V St Lot Apartments

15th St NW and V St NW, Washington, DC

RESPONSE TO HPRB COMMENTS

Perspective

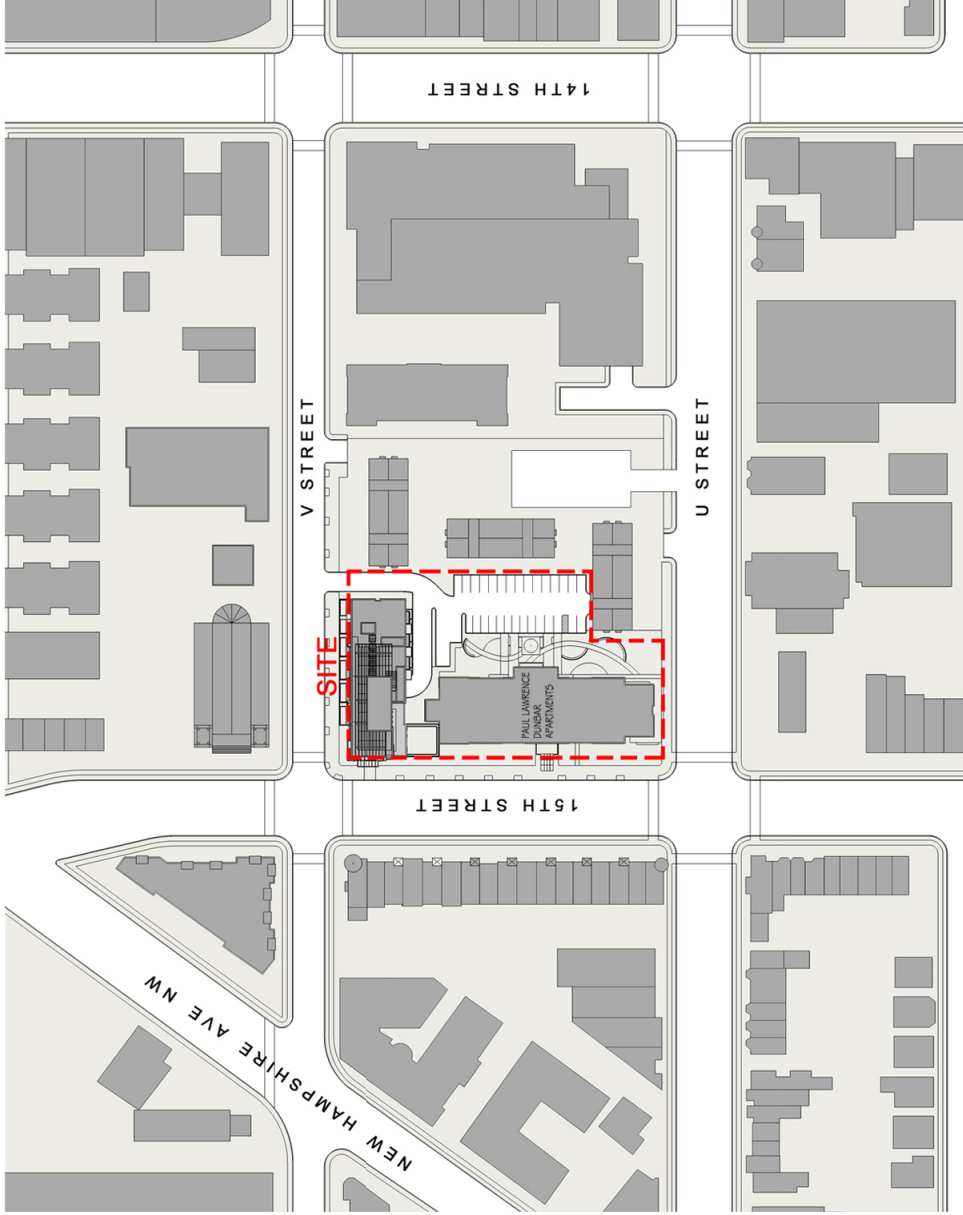
1. Review the glass to brick ratio of the 1st floor units along the V Street façade to add value to the units
 - The façade of ground floor residential units has been revised to reflect the changes of the main building façade above. For each unit's façade, continuous masonry base and intermediate vertical metal panel trim have been added to reduce the amount of glazing.

2. Be respectful of / compliment the Church towers as they relate to the glass bays on V Street and 15th Street façade faces
 - Both V St. & 15th St. façades have been carefully studied as a whole. The reduction of glass on each bay along V Street allowed wider masonry gap between the bays. By sliding the group of 4 bays towards the east, it creates a wider masonry "buffer" from the corner bay and introduces more interesting visual rhythm to the overall composition.

- The width of the vertical metal panel frame at each bays' end has been reduced to express more delicate profile for the bays.
3. Review 15th St façade for the glass to brick ratio to improve the design

4. Concerned about the openness of the bays into the units from the exterior. Consider adding a frit to the lower sections of glass to provide privacy to the owners and respect to those that may be looking up

- The northwest corner bay has been revised both in its size and articulation by reducing the glass from both sides and it provides more slender profile along 15th Street to be compatible with the Church towers' scale.

- In addition to the changes on the corner bay, the punched openings in the southwest corner also have been revised to a pair of two smaller openings rather than one large one to provide "finer texture" for the masonry wall. The western façade now has two distinct end treatments that are better proportioned and are carried by a strong vertical masonry anchor.

- Translucent frit has been added for all bays' lower sections to add privacy to the units. The pattern is added at every other floors to preserve the two-story rhythmic reading.
